REMARKS

Appln. No. 10/611,912
Amdt. dated October 26, 2004
Reply to Office Action of July 26, 2004

FIG. 3

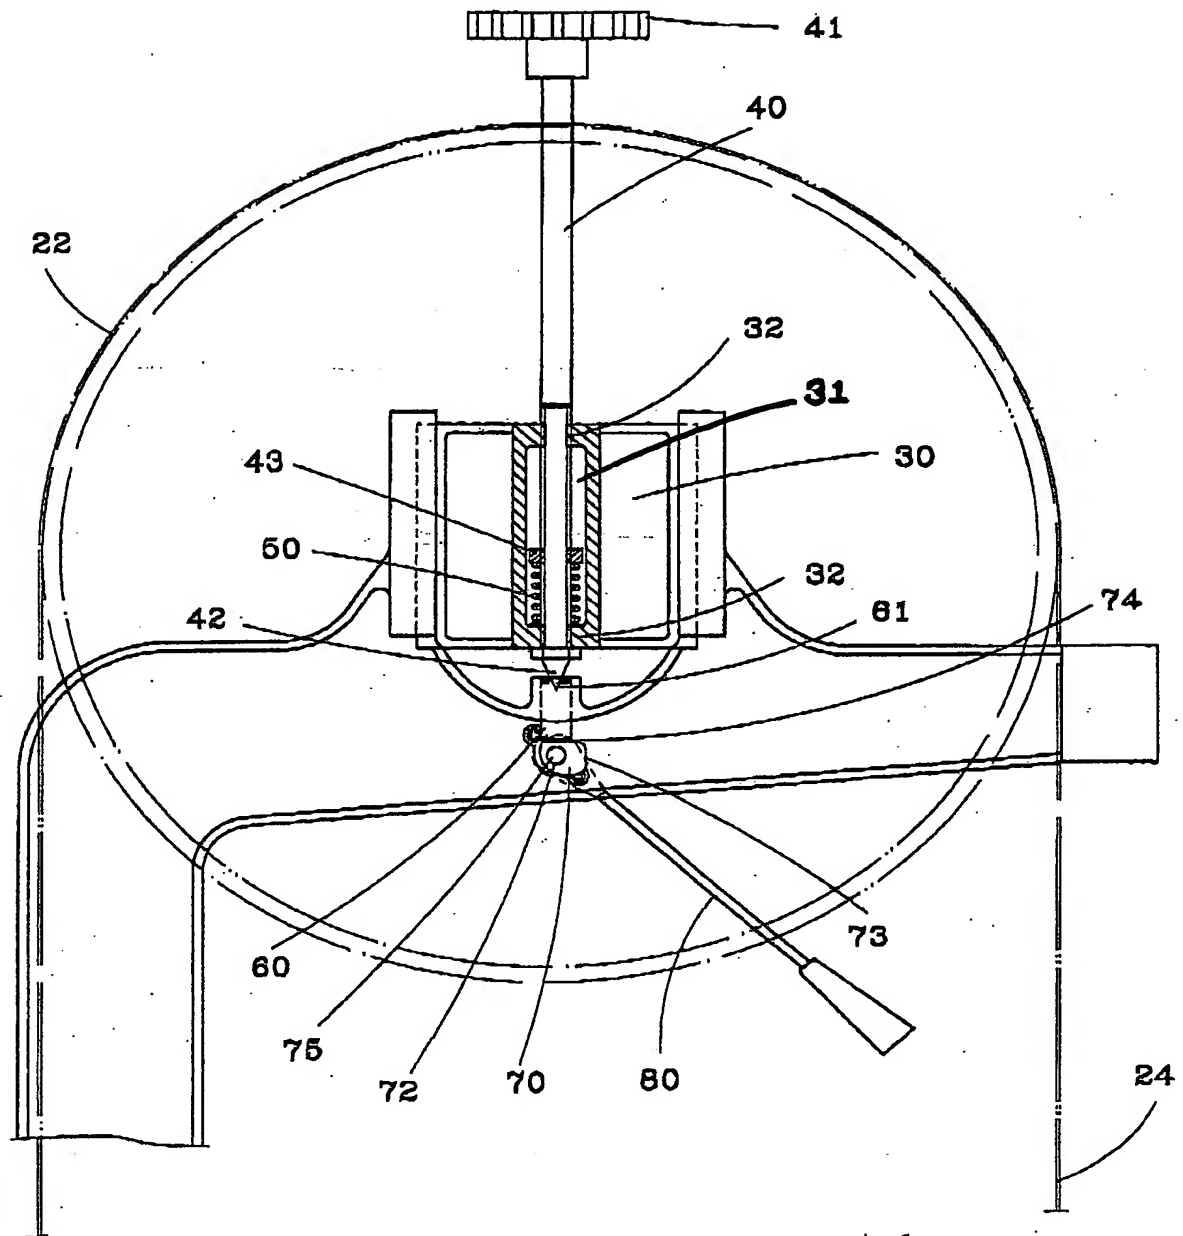
In response to the Examiner's objection to the drawings, Applicant has enclosed an amended Fig. 3 showing element 31.

The attached drawing sheet includes Figure 3 only.
This sheet replaces the original sheet including Figure 3 in
which previously omitted element 31 has been added.
